IMPROVEMENTS TO LINCOLN AVENUE, HAGEMOUNT AVENUE AND ROCKY BROOK COURT BOROUGH OF HIGHTSTOWN, MERCER COUNTY, NEW JERSEY

May 21, 2019

Re: Design Recommendations

LAYOUTS DESIGNED PER BOROUGH OF HIGHTSTOWN ENVIRONMENTAL COMMISSION COMMENTS

PLAN A - 21' CARTWAY WITH PARKING ON NORTH AND SOUTH SIDES

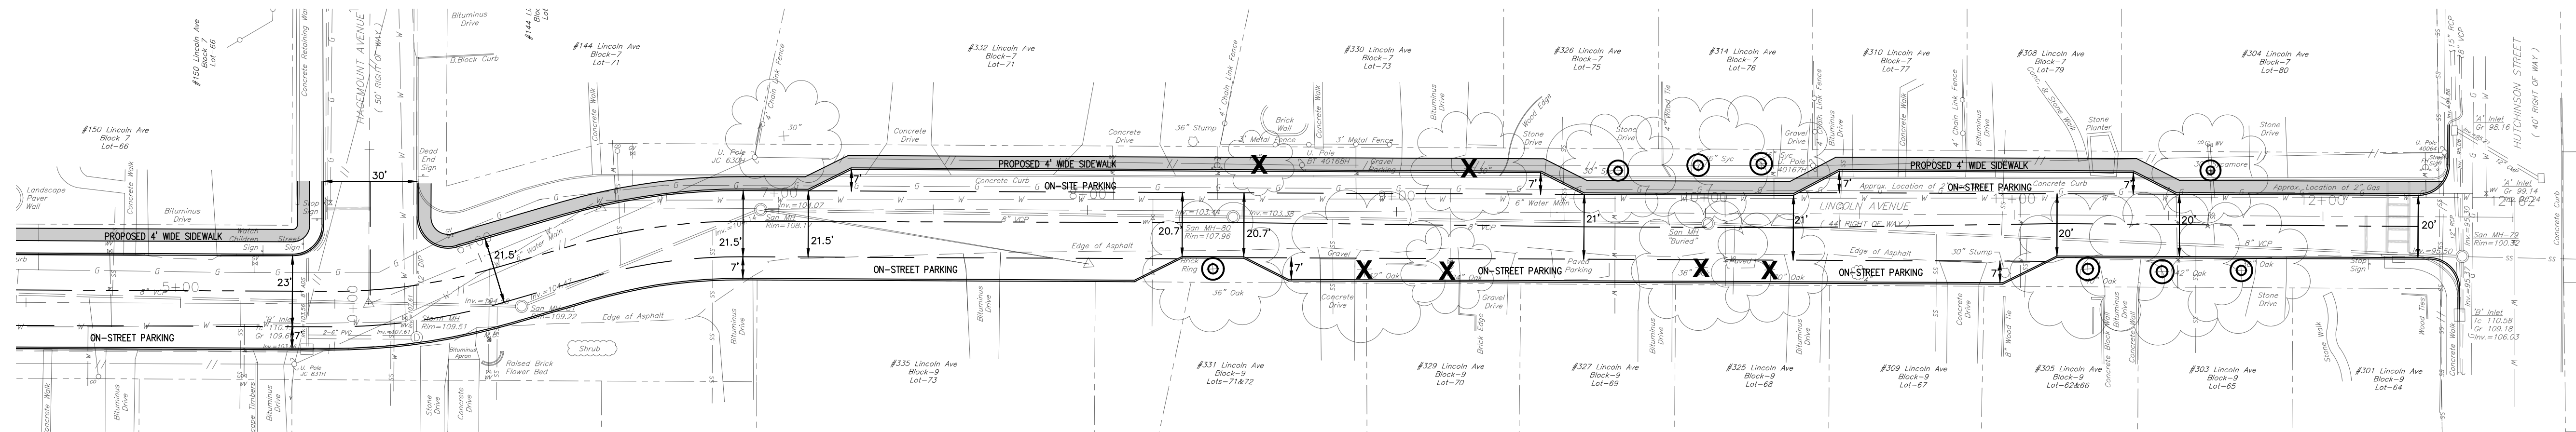
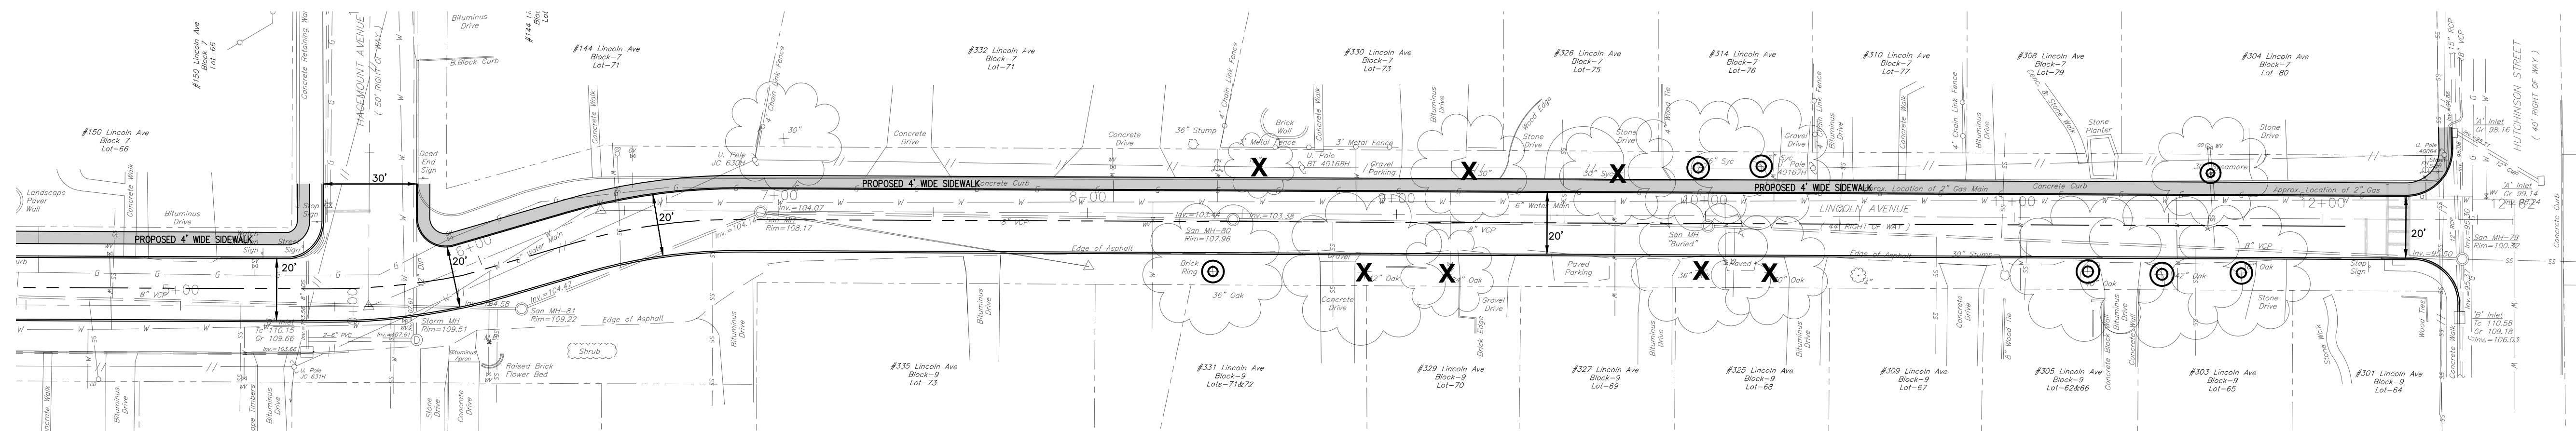
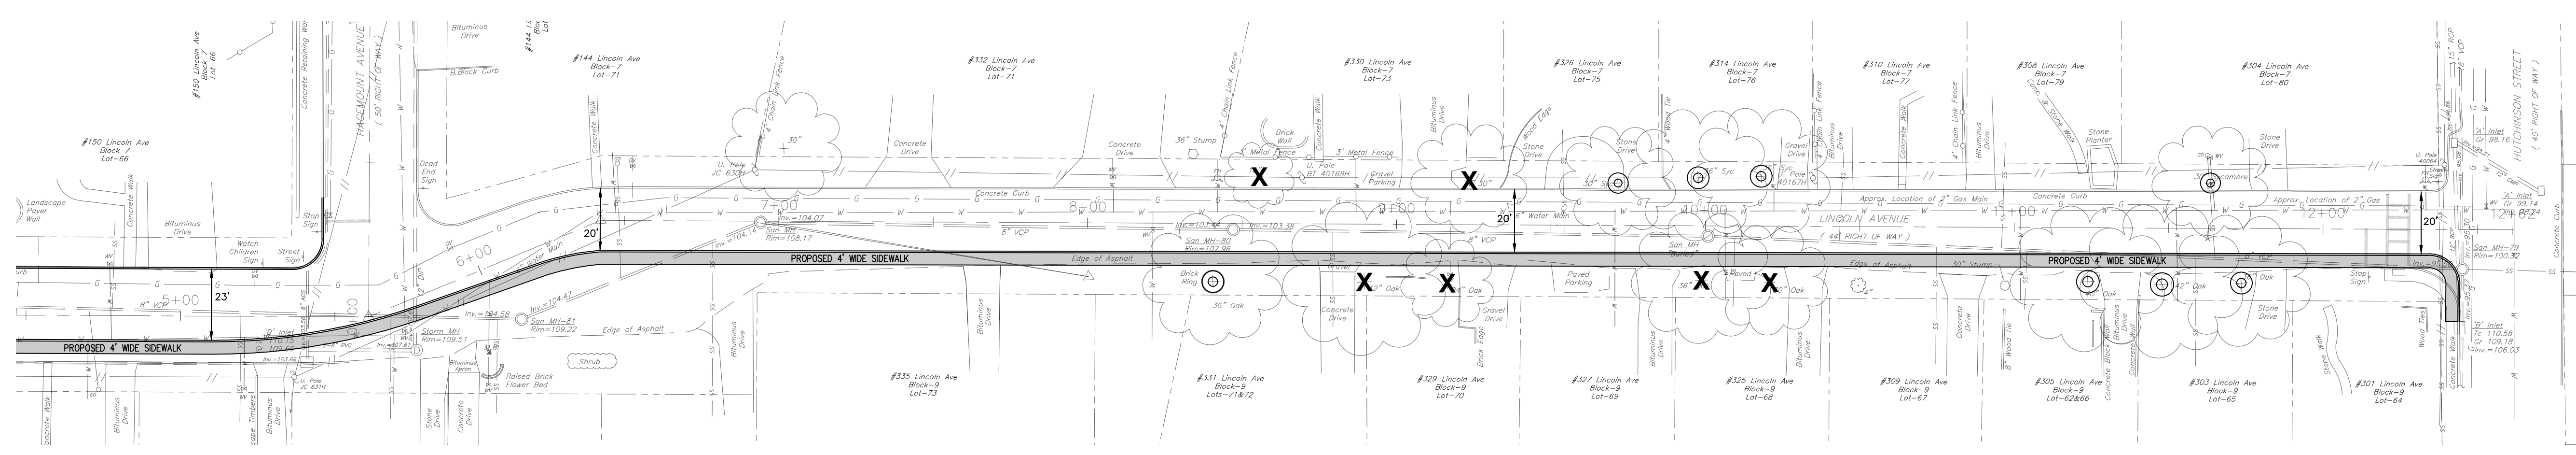
In support of ongoing development of a project to add sidewalks, repair curbs and in general, improve the streetscape of Lincoln Avenue, Rocky Brook Court and Hagemount Avenue in their entirety. Environmental Commission and Tree Committee member, Yan Trioizier and I reviewed conditions at the project area and are recommending the following:

The following trees were observed to be in poor conditions. We recommend their removal as part of the scope of this project:

Lincoln 303	Remove (1) Large Oak
Lincoln 305	Note that both large oaks should be saved
Lincoln 325	Remove (2) Large Oaks
Lincoln 329	Remove (1) Large Oak, (1) Large Maple
Lincoln 330	Remove (2) Large Maples (one on the east and one on the west side of the lot edge)

PLAN B AVOIDS REMOVAL OF THE ABOVE 7 INDICATED TREES. IT IS EXPECTED THAT THERE WILL BE DAMAGE TO THE TREES WHICH ARE TO REMAIN.

PLAN B AVOIDS REMOVAL OF THE ABOVE 7 INDICATED TREES. THE TREE AT 326 LINCOLN AVENUE WILL REQUIRE REMOVAL. IT IS EXPECTED THAT THERE WILL BE DAMAGE TO THE TREES WHICH ARE TO REMAIN.

PLAN C AVOIDS REMOVAL OF THE ABOVE 7 INDICATED TREES. IT IS EXPECTED THAT THERE WILL BE DAMAGE TO THE TREES WHICH ARE TO REMAIN.

NOTE: THE CONCEPT LAYOUTS SHOWN ON THIS PLAN ARE BASED ON A TREE EVALUATION BY D. ZAISER OF THE BOROUGH ENVIRONMENTAL COMMISSION AS OUTLINED IN A MEMO DATED JUNE 24, 2018.

PLAN D - 21' CARTWAY WITH PARKING ON NORTH SIDE

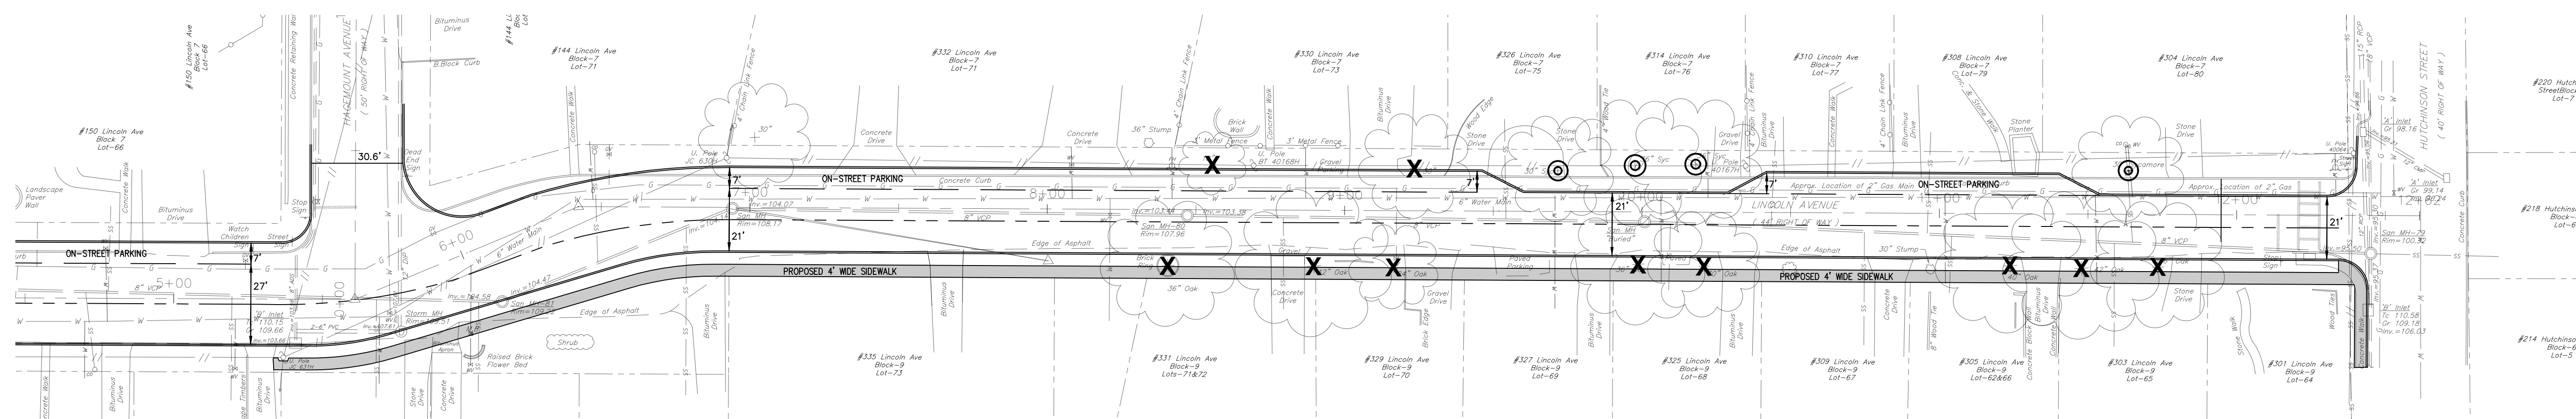
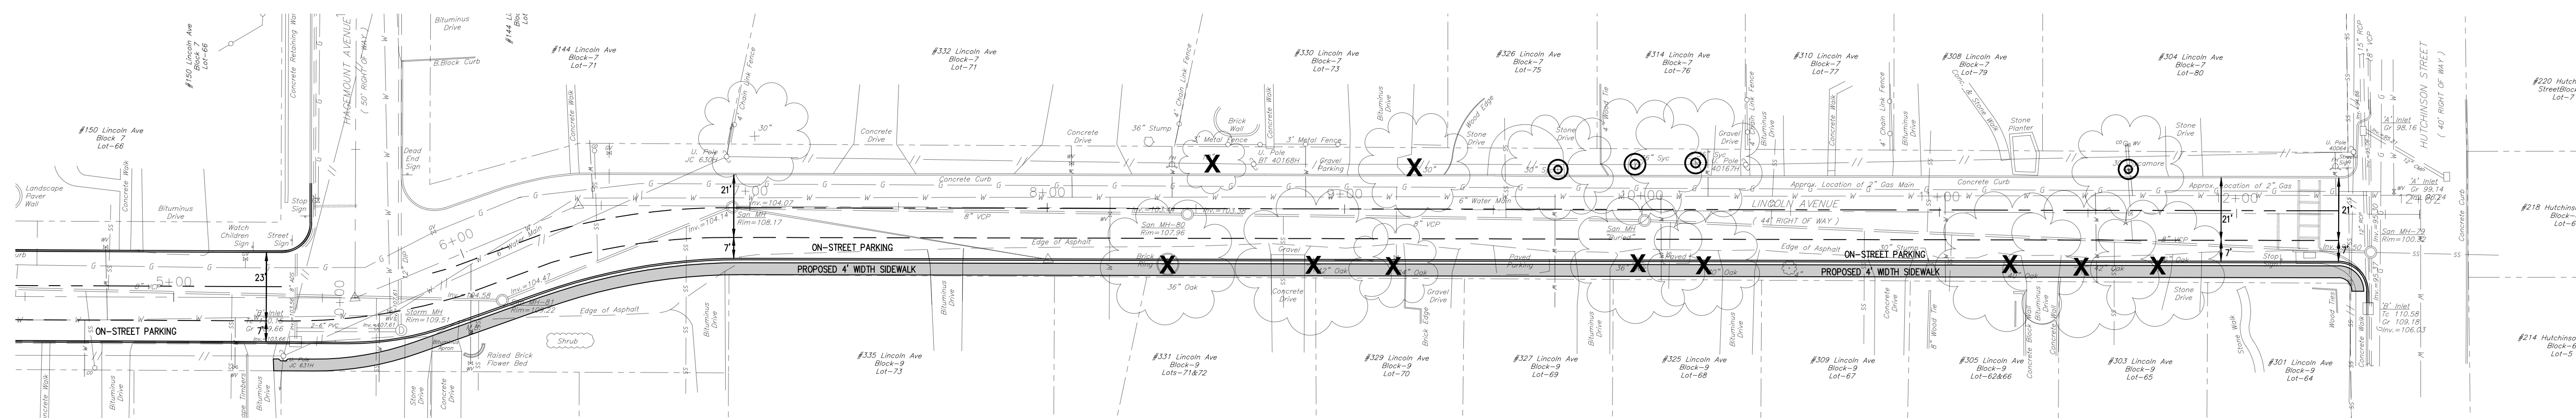
This letter is for Hightstown Borough concerning the trees on Lincoln Avenue. All of the seven Oak Trees, on the south side of Lincoln Avenue appear to be infected with Bacterial Leaf Scorch. Number five of the Oak trees is totally dead and #1, #4, #6, and #7 are in the worst shape of them all. Oak Trees #2 and #3 look the best out of the seven but they still appear to be infected. The work being performed around these trees will require cutting of roots and compacting the soil which will most likely speed up their demise. I would consider removing all these trees.

The London Plane trees on the north side of Lincoln Avenue have a good chance of surviving the road work. I am concerned that the water lines look like they would have to damage a lot of the root system or trunk flare. Where this is true, consider removing the tree. If the sidewalk is to be put on this side of road, leave plenty of room for additional trunk growth.

If preservation is your goal, work should be performed as far away from trunk flare and root system as possible. Tree trunks should also be protected from being damaged by construction equipment.

PLAN D AVOIDS REMOVAL OF THE ABOVE 4 INDICATED TREES. IT IS EXPECTED THAT THERE WILL BE DAMAGE TO THE TREES WHICH ARE TO REMAIN.

NOTE: THE CONCEPT LAYOUTS SHOWN ON THIS PLAN ARE BASED ON A TREE EVALUATION BY JOHN STANLEY OF TIMBERWOLF TREE SERVICE, INC. IN A LETTER DATED APRIL 3, 2019.

PLAN E AVOIDS REMOVAL OF THE ABOVE 4 INDICATED TREES. IT IS EXPECTED THAT THERE WILL BE DAMAGE TO THE TREES WHICH ARE TO REMAIN.

PLAN F - 21' CARTWAY WITH PARKING ON SOUTH SIDE

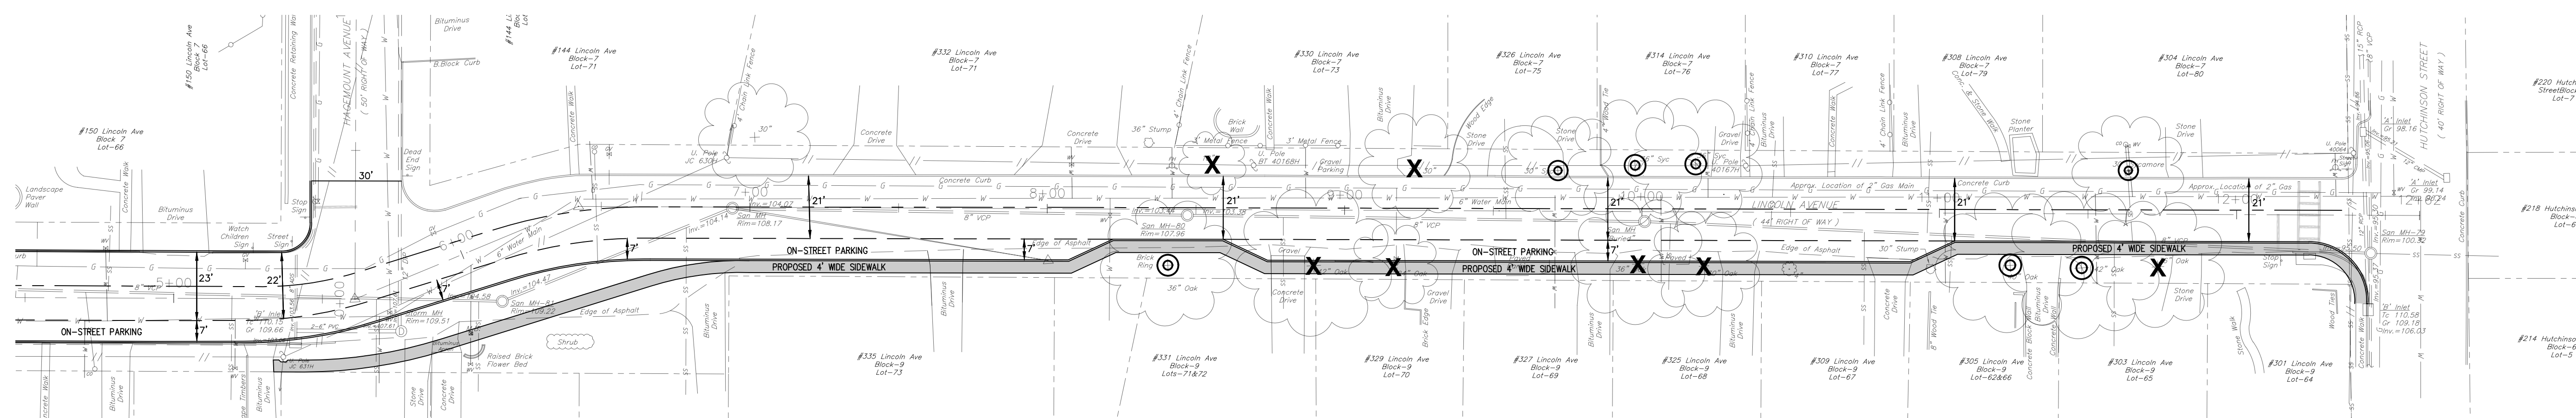
Two trees on the north side of Lincoln Avenue should be removed. The first is a 20" Diameter at Breast Height (DBH) Norway maple at 330 Lincoln that has mushrooms at the base that indicate shoe string root rot. This tree is dying and possibly unstable depending on the extent of the root rot. The second is a 30" DBH silver maple also at 330 Lincoln that has an extensive hollow at about five feet and has signs of recent extensive branch breakage that is a notorious problem for this species.

Many of the pin oaks along the south side of Lincoln Avenue are exhibiting symptoms of bacterial leaf scorch. This bacterial disease clogs the water conducting elements of affected trees causing the trees to die back from the outside and top of the crown toward the trunk of the tree. Sprouting on the trunk and large interior branches is common. There is no "cure" for this disease with treatments only prolonging the decline of the trees. While many tree species are susceptible to bacterial leaf scorch, it has been my experience that pin oaks, and red oaks are affected most severely. Not all pin oaks will get the disease. Those that do succumb usually take several years to die completely but produce copious amounts of hazardous dead branches in the process. Generally, affected trees (described in the next paragraph) should be removed rather than pruned to prevent large deadwood from falling from the tree.

On the south side of Lincoln Avenue, there is a 34" DBH pin oak at 303 that is dead and should be removed. At 325, there is a 42" pin oak that is half dead. Also at this address is a 30" DBH pin oak that has lost about 30% of its crown and appears to be in low vigor. Both trees at this address should be removed. At 329, there is a 42" DBH pin oak that appears to be in low vigor with about 20% of its crown dead and deadwood larger than 4 inches in diameter. I believe this tree will continue to produce large dead branches over the next few years as it continues to decline. A case could be made to remove this tree at the same time as the other removals. Also at this address is a 32" DBH Norway maple that has weak fork at about 5 feet. This tree is likely to fail at this weak fork and should be removed.

I would discourage the placement of a sidewalk along the London plane trees on the north side of Lincoln Avenue. These trees if left undisturbed, can provide decades more benefits to the community with almost no maintenance by the Borough of Hightstown. In contrast, there are several trees on the south side of the street that are doing poorly and should be removed or some may be pruned heavily. Installation of a curb along the south side of Lincoln Avenue would have minimal impact to the trees if the curb line were set at the minimal roadway width that would be within the existing pavement zone. However, this would narrow the street significantly. If a sidewalk is to be installed, and it is best to install it on the south side to avoid the London plane trees, one should consider, a wider street with on street parking because most of the trees on the south side already need major work in the form of extensive pruning or removal. If a sidewalk and curb are to be installed along the south side of the street, I recommend the removal of all the trees on the south side of the street in the work zone.

NOTE: THE CONCEPT LAYOUTS SHOWN ON THIS PLAN ARE BASED ON A TREE EVALUATION BY KEVIN L. SCIBILIA OF FORESTRY CONSULTING, LLC. AS OUTLINED IN A LETTER DATED APRIL 20, 2019.

PLAN F AVOIDS REMOVAL OF THE ABOVE 6 INDICATED TREES. IT IS EXPECTED THAT THERE WILL BE DAMAGE TO THE TREES WHICH ARE TO REMAIN.
